## PC QUESTIONS

Diagram 1  
Computer Chassis with Protruding Bracket

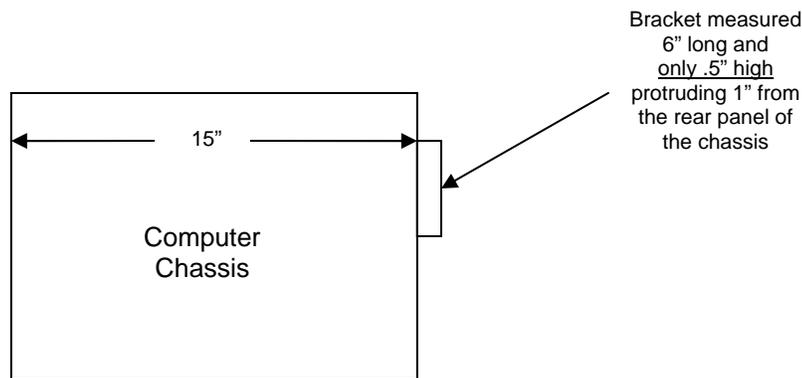
The requirement calls for a chassis with maximum dimensions of 15”(H)x15”(W)x4”(D). Would the Government consider a chassis that has a width of 15” but contains a small bracket measured 6” in length and .5” in height that protrudes approximately 1” from the rear panel acceptable? Except for this very small protruding bracket, the chassis otherwise complies with all other dimensional requirements. Please see the diagram below.

**8. Answer:** No. The Not-To-Exceed Requirement is Firm.
